WATER PERMIT NO. FC34A-3

Remarks: **Revisions to flood control project which includes rock arch rapids through the diversion channel and revisions to a weir structure, resulting in minor changes in flow through the city of Brown Valley.**

FLOOD CONTROL PERMIT NO. FC34A-3

Figure 3. Proposed rock arch rapids layout, modified from Odens (2025).

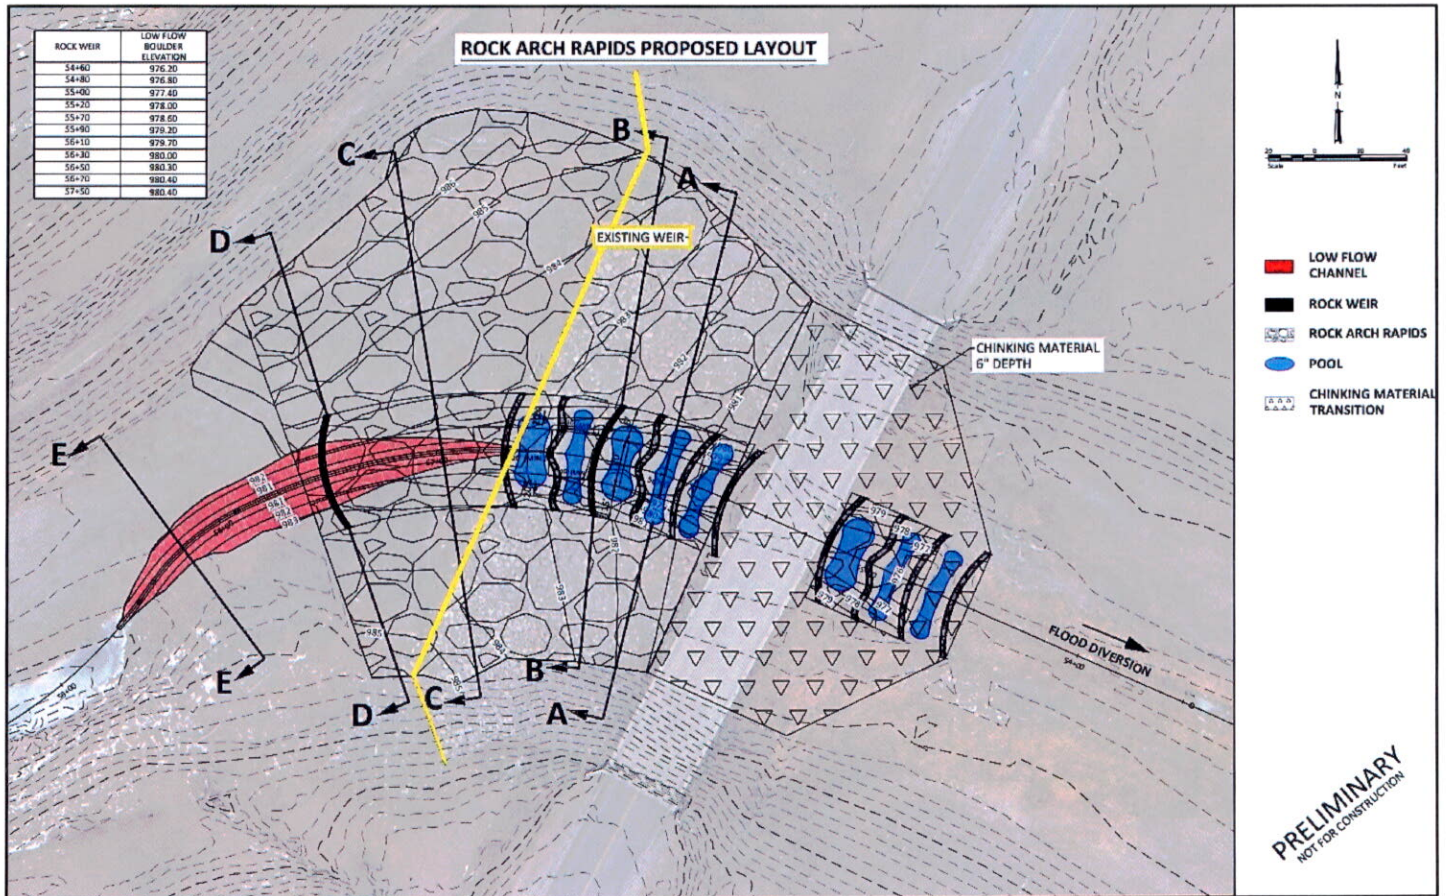
According to the 90% design report, the proposed new location of the controlling cross section is to be at D-D' (see **Figure 3**), upstream of the existing weir by approximately 80 feet near the inlet of the rock arch rapids structures, and has a high breakover elevation of 983 feet and the low flow channel (2 feet bottom width) at an invert elevation of 980.4 feet. The low flow section comes up at 5H:1V slope to the higher

flow section at 983 feet. Therefore, the controlling cross section is changing location and its controlling elevation, which will be lowered by approximately 4.74 feet from 985.14 feet (current) to 980.4 feet (proposed). The existing weir will be cut down to where it will tie into the elevation of the rock arch rapids at that location (approximately 980.4 feet), and will be cut to match the slope of the channel (5H:1V). **Figure 3** below shows the new location of the controlling cross section (D-D' from design plans) and the rock arch rapids structures layout (Odens, 2025)

Figure 4. Browns Valley Flood Control Dam Spillway Curves (Odens and Hullinger, 2025).

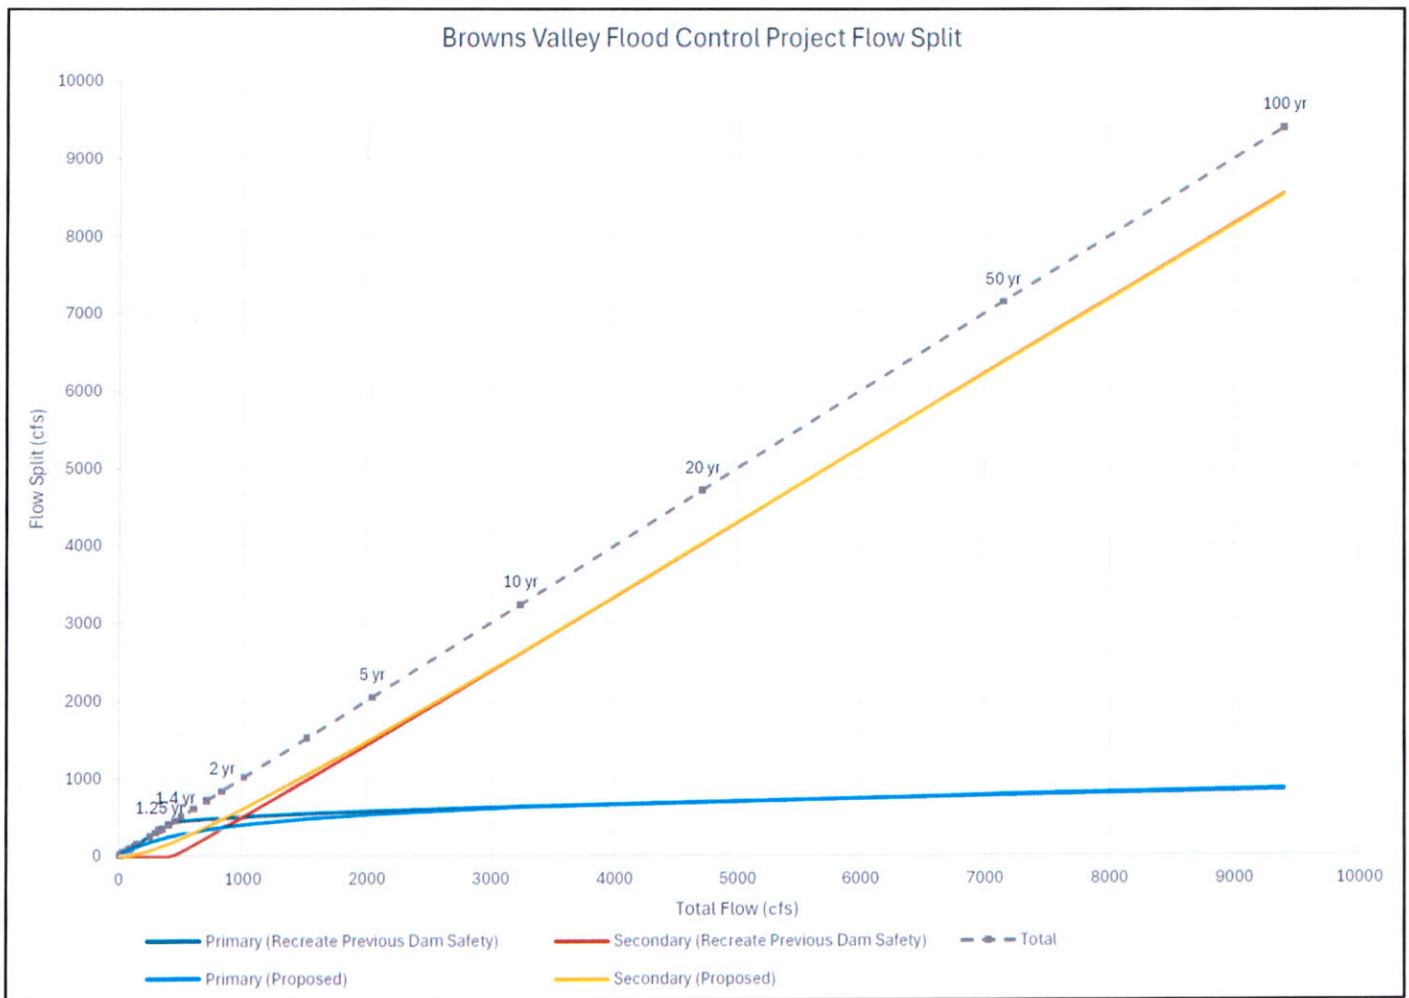
Since this application proposes to alter the dam (design by Houston Engineering), the alteration is required to be reviewed and approved by the Chief Engineer pursuant to ARSD 74:02:08:09. Since this is not a typical water storage dam (which is what the State's rules are primarily designed for), certain interpretations were needed to evaluate this structure in relation to the South Dakota Safety of Dams Rules. At the time of original permitting for FC34-3, the primary spillway was considered to be the box culvert and the secondary spillway was considered to be the flood diversion channel (floodway) with the control section being the sheet pile control weir structure.

The alteration proposed by this project moves the control section upstream of the rock rapids arches and lowers the elevation of the control section up to 4.74 ft. The flow information shown on **Figure 4** provided by Houston Engineering indicates that the alteration would retain the spillway capacity required of a small, sized category 2 dam (100-year, 24-hour storm event) and the alteration would only change the distribution of flows between the spillways at smaller events (less than 10 year). No change to the dam height or maximum storage is being proposed, so the size classification will remain small.

To complete the Safety of Dams review an updated spillway capacity curve will be needed to be submitted to reflect the changes to the secondary spillway, and that a different sized box culvert was installed for the primary than what was approved in the 2008 Safety of Dams review. Additionally, the design report is unclear if the sheet pile weir location will continue to be the control section for the secondary spillway, and the location of the control section will also need to be clarified.
